Torque Converter Flex Lock-up Shudder

Applicability

YEAR(S)	MODEL(S)	ADDITIONAL INFORMATION
2012 – 2014	Camry	VDS(s): BF1FK

The information contained in this bulletin supersedes SB No. T-SB-0086-12.

Figure 1. Magnet Installation Locations

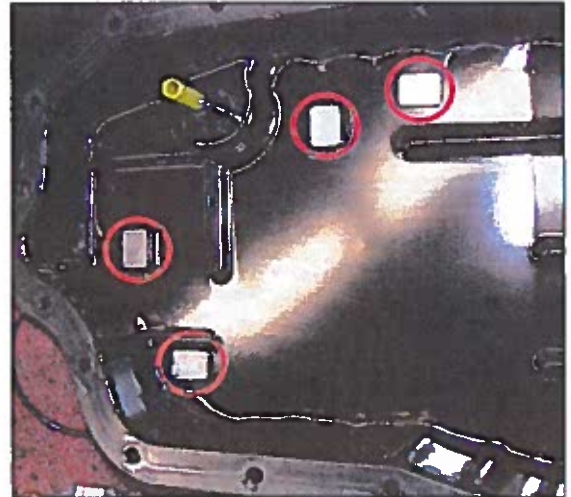
6. Install 4 NEW magnets in the locations shown in Figure 1.

Figure 2. Location of Authorized Modifications Label on 2012 – 2014 Camry

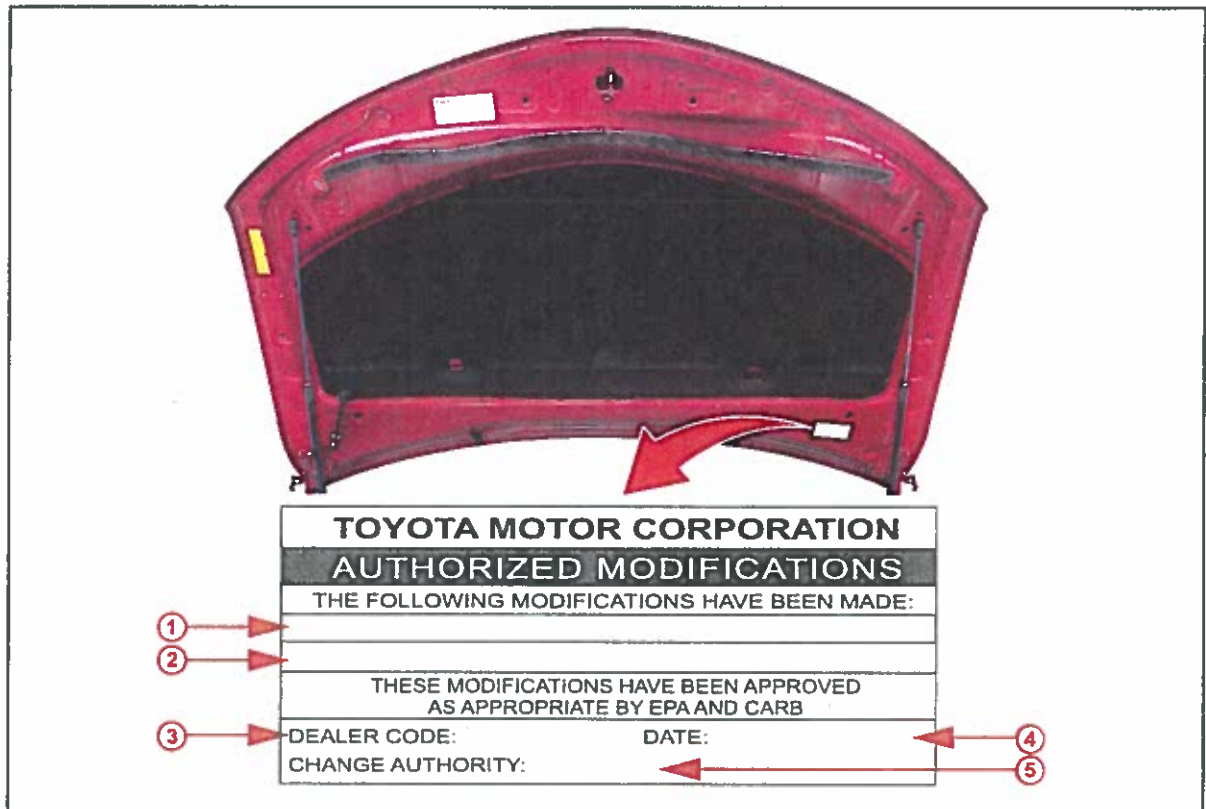
- Check for the Authorized Modifications Label affixed to the vehicle in the location shown in Figure 2 below. Confirm if the ECM (PCM) calibration has been updated. If the calibration ID listed is NOT the latest ECM (PCM) calibration — go to step 10. If the calibration ID is the latest, go to step 12.

11. Install the Authorized Modifications Label.
 - A. Using a permanent marker, enter the following information on the label:
 - ECM part number [*Refer to the **Parts Information** section for the **NEW PART NUMBER***]
 - Calibration ID(s) [*Refer to the **Calibration Information** section for the **NEW CALIBRATION ID***]
 - Dealer Code
 - Repair Date
 - Change Authority [*This bulletin number*]
 - B. Affix the Authorized Modifications Label to the vehicle at the location shown in Figures 2. The Authorized Modifications Label is available through the MDC, P/N 00451-00001-LBL.
12. Test drive to confirm the repair.
